Overview: Production error; immobilizer wire (orange/black) in pin position #4 instead of pin position #5. Although an effort to correct the issue was made, some quantity of harnesses did get shipped before the issue was spotted. We are advising to inspect the harness BLADE connector before attempting to install the harness and program the module.

Descripción general: El nuevo arnés en T FTI-STP1 requiere modificaciones para su uso en aplicaciones de transmisión automática (AT).

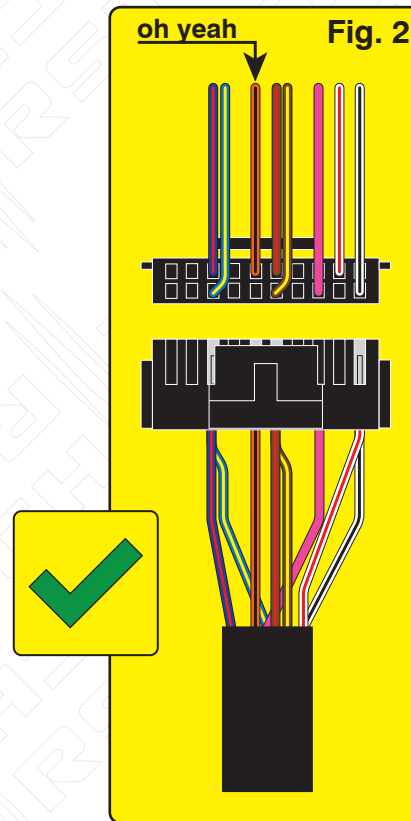
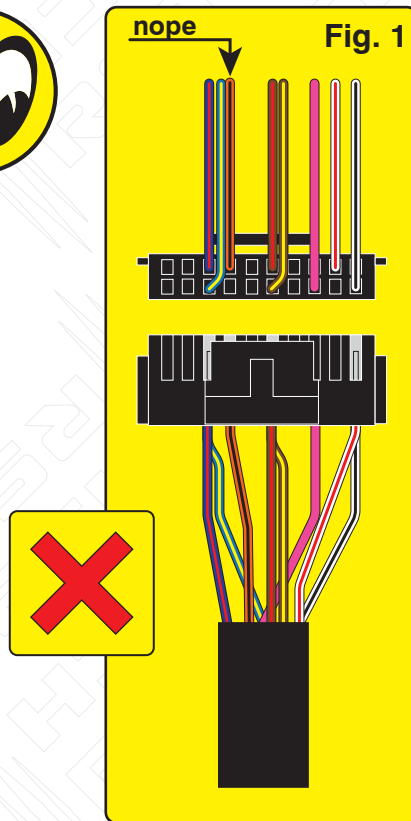
Issue: Module fails to program to vehicle, will not allow the vehicle to be remote started.

Correction: Step 1.) Locate the orange/black wire and confirm whether it is positioned as illustrated in Fig. 1 or Fig. 2. If the wire is as illustrated in Fig.1, proceed with Step 2 through 5 and complete the repair procedure outlined, if the wire is as illustrated in Fig. 2, correction is not necessary, proceed with harness installation and module programming.

Step 2.) Using a pick, lightly depress the catch that secures the terminal in the housing then remove the wire and terminal from the housing.

Step 3.) Using a fine tip razor or utility knife, insert the blade beneath the terminal catch and raise it slightly, so that it can be reused to secure the terminal when reinserted into the BLADE connector housing.

Step 4.) Refer to Fig. 2 for correct position of the orange/black wire (next to brown/red) then reinsert the terminal, pressing lightly until the catch 'snaps' into place, securing the terminal in the connector housing.

Step 5.) The repair is complete, proceed with installation and programming.

MODIFICACIÓN REQUERIDA PARA APLICACIONES DE TRANSMISIÓN AUTOMÁTICA ÚNICAMENTE

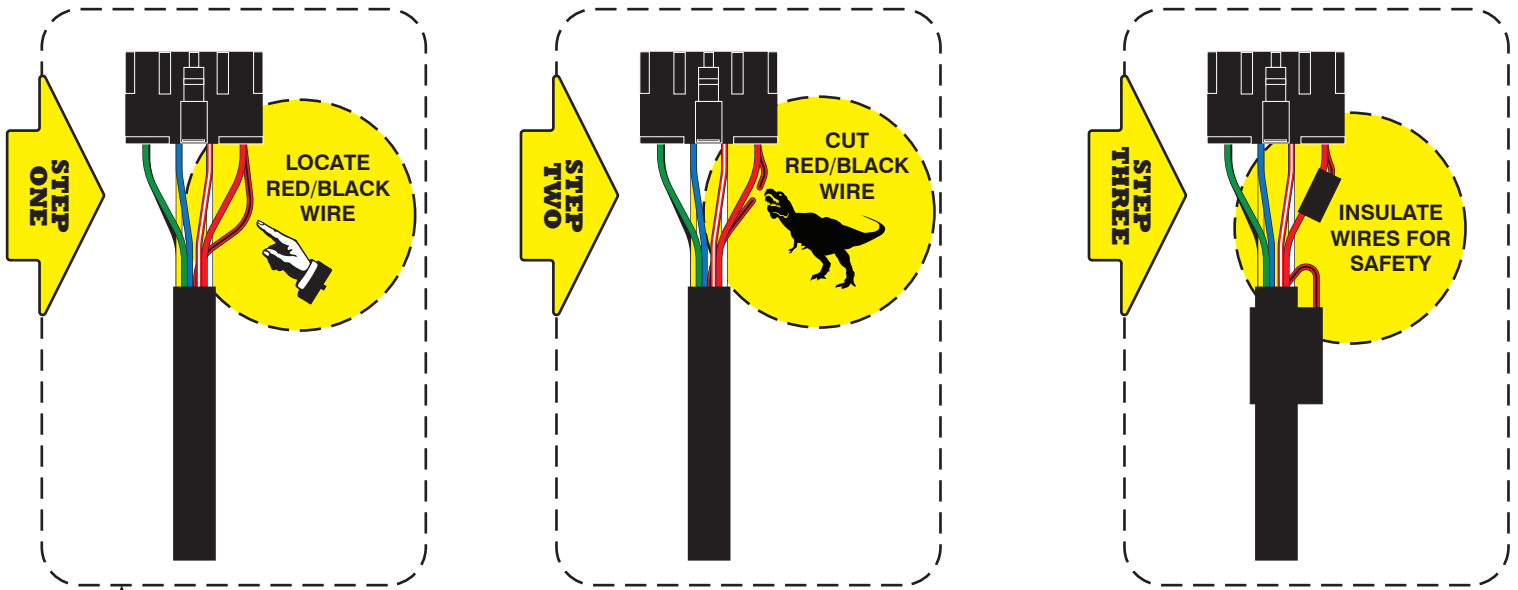
Problema: El arnés en T FTI-STP1 ha sido diseñado para ser compatible con AT (transmisión automática) y MT (transmisión manual), pero debido a una supervisión de la producción, el mecanismo de selección se estableció por defecto en el modo MT.

El uso de un arnés configurado para una aplicación MT, en un vehículo equipado con AT, podría provocar daños en el módulo del vehículo. Se recomienda que el arnés vuelva al modo AT antes de instalarlo en vehículos equipados con transmisión automática.

Corrección: Localice el cable rojo/negro (+ embrague) provisto en el conector CN1 del conjunto del arnés principal. Corte el cable rojo / negro, ya sea al ras del conector CN1 o dejando suficiente cable expuesto para que pueda aislar y asegure los extremos del alambre que quedan después del corte. Aísle cada uno de los extremos restantes del cable rojo/negro y asegúrelos para evitar cualquier posibilidad de cortocircuito.
